Subject: Endurant HD AT and PACCAR AT Mechatronic Transmission Module (MTM)
Loose Rail Cover Cap Screws

Document Number: TAIB-0994

Date: July 19, 2021

Vender MTM Serial Number Decoder from example above

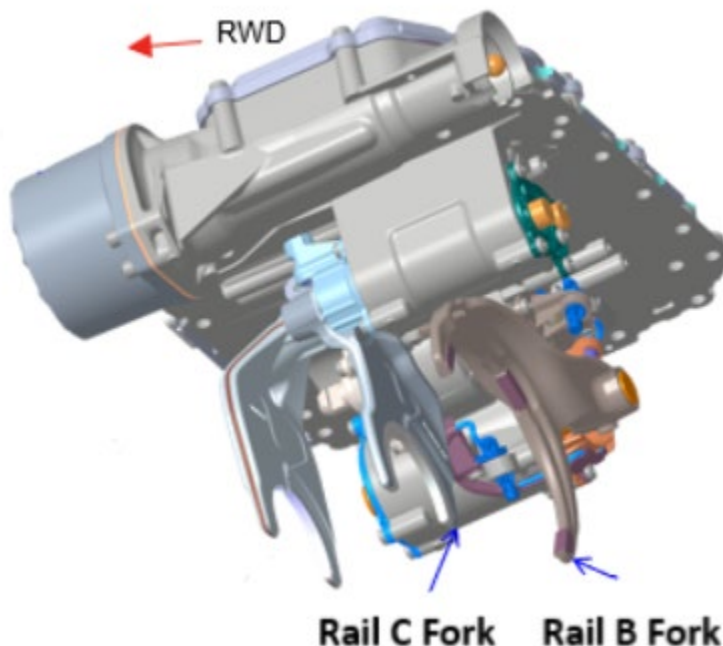
1. July 29, 2019 - 100% visual inspection to verify Loctite was applied to cap screws and rail covers were fully seated.
2. August 23, 2019 - rail cover cap screw torque was increased to 12.5 Nm.
3. September 4, 2019 - implemented refined machining process and sorting at manufacturing plants.
4. Julian Date Build Date Code etched into MTM Housing:

- 12S18341102918 = 2018
- 12S18341102918 = 341st day of 2018 (December 7, 2018)

MTM Rail Cover Locations

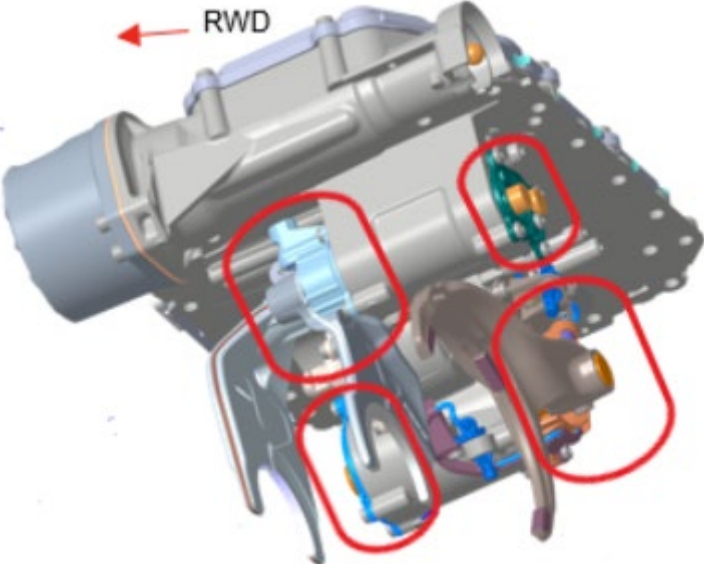
MTM Rail B and Rail C Identification

Rail B Rail Cover Loose Cap Screw Identification

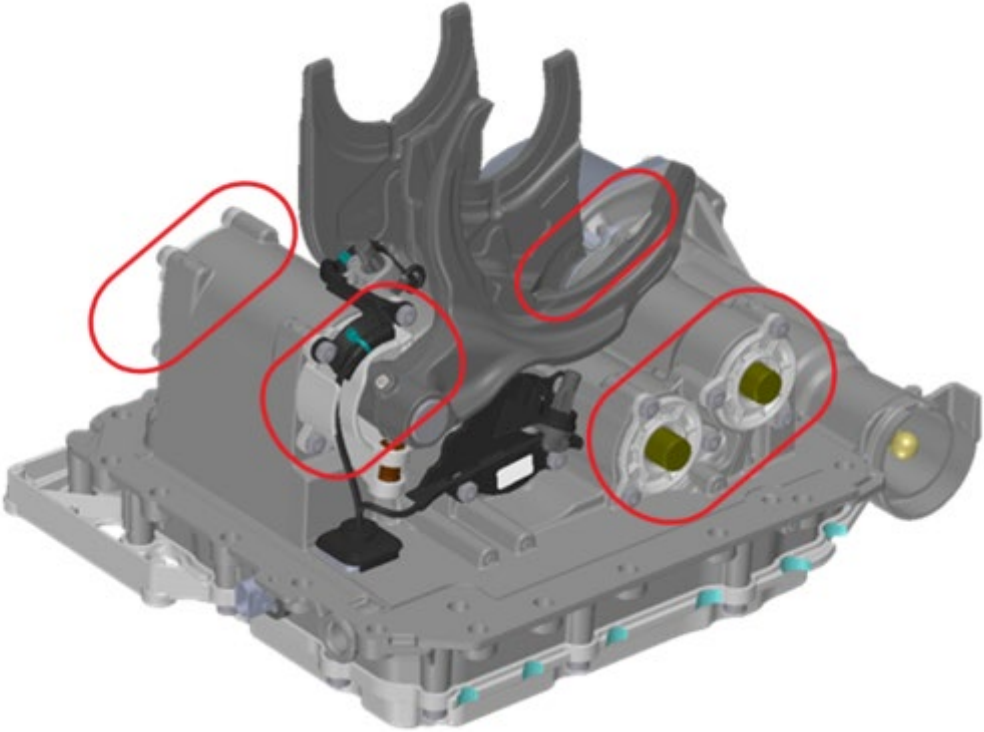
- Perform service procedure ONLY if a rail cap screw is visibly loose.
- Pictures, loose screw position, and MTM serial number must be documented in the warranty claim.
- If no loose rail cap screws are visibly verified, no further service is needed.

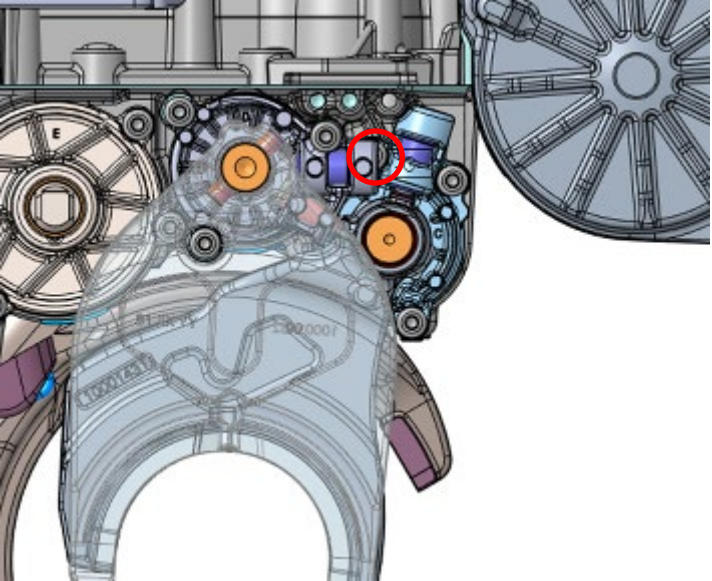
There is one cap screw on Rail C that is not accessible. Do not disassemble any other components to access this cap screw. If this cap screw is visibly loose replace the MTM.
